APPLICATION NO.	FILING DATE	FIRST NAMED INVENTOR	ATTORNEY DOCKET NO.	CONFIRMATION NO.
09/437,296	11/09/1999	MICHIO YAMAJI	991283	7789

Office Action Summary	Application No. 09/437,296	Applicant(s) YAMAJI ET AL.	
	Examiner Aaron M Dunwoody	Art Unit 3679

DETAILED ACTION***Continued Examination Under 37 CFR 1.114***

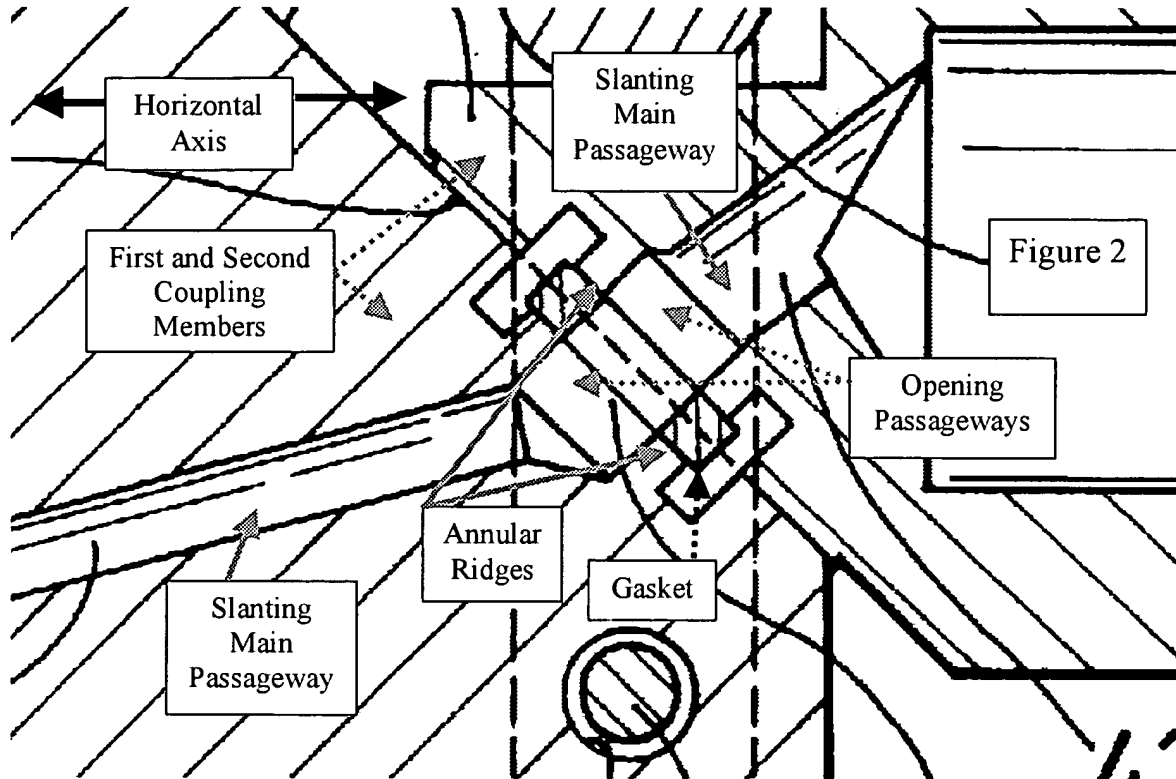
Claim 1 is rejected under 35 U.S.C. 103(a) as being unpatentable over US patent 5967489, Nakazawa et al in view of US patent 5505464, McGarvey.

In regards to claim 1, in figure 2 below, as best understood, Nakazawa et al discloses a fluid coupling comprising first and second coupling members having respective gasket holding annular ridges on butting end faces thereof; and

an annular gasket interposed between the first and second coupling members, wherein each coupling member has a fluid channel comprising an opening passageway orthogonal to the butting end face thereof, and a slanting main passageway communicating therewith, the opening passageway having a diameter equal to the inside diameter of the gasket holding annular ridge, and

the gasket holding annular ridges are in contact with the gasket at its radial midportion so as (capable) to relieve the inner peripheral portion of the gasket from stress concentration and wrinkles.

Nakazawa et al does not disclose the gasket holding annular ridges being rounded as to be in contact with the gasket only at its radial midpoint. In Figure 6, McGarvey teaches gasket holding annular ridges (76, 78) being rounded as to be in contact with the gasket (52) only at its radial midpoint to produce a minimum dead zone volume condition (col. 1, lines 45-64). As McGarvey relates to face-seal fitting employing a metal gasket, it would have been obvious to one having ordinary skill in the art the time the invention was made to fabricate rounded gasket holding annular ridges as to be in contact with

the gasket only at its radial midpoint to produce a minimum dead zone volume condition, as taught by McGarvey.
